Environmental Planning Commission

Staff Report

Agenda Number:4
Project #: PR-2020-004086
Case #: SI-2020-00690
Hearing Date: September 10, 2020

Agent	Consensus Planning, Inc.
Applicant	Titan Property Management, LCC
Request	Site Plan – EPC and Variance - EPC
Legal Description	Tract 1 The Foothills
Location	Tennyson Street NE (E-22)
Size	16.05 acres
Existing Zoning	R-MH

Figure 4. Proposed 5-foot setback at the southeast corner of the site with future AMAFCA Access Road highlighted in green.

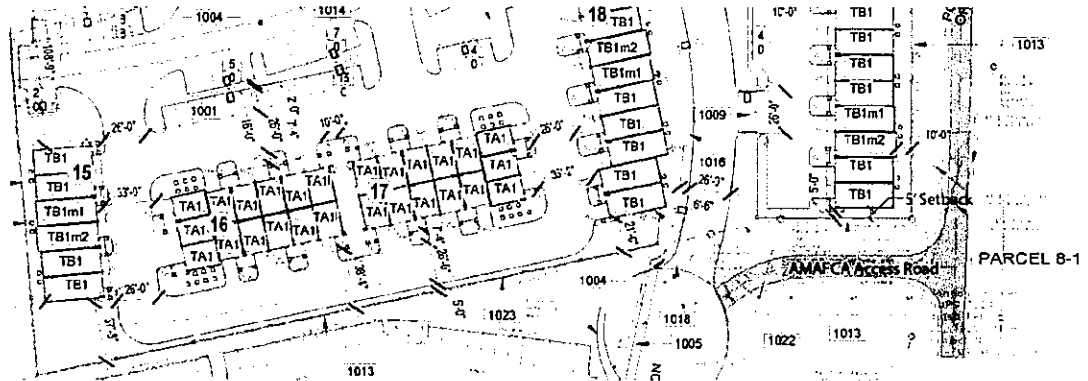
As part of this Site Plan – EPC request, the Applicant is also seeking approval of a Variance – EPC to allow the building at the southeastern corner of the subject site to be placed with a setback of 5 feet from the front property line (See Figure 4 on the following page). Per the required pre-application discussion with staff, the southern lot line is considered the front as it borders on Tennyson Street where the primary vehicular access is proposed. However, most of this property line functions like a side lot line and there are other special circumstances that warrant approval of the request variance.

Further, front lot lines usually border a street along their entire width; however, the south property line only borders Tennyson Street for a small portion of its width, while the remainder borders adjacent properties. Any other similarly situated property at the end of a cul-de-sac would treat the lot line extensions from the cul-de-sac and adjacent to other properties as side lot lines. If that were the case, no variance would be required because the side setback requirement is only 5 feet (see Figure 4).
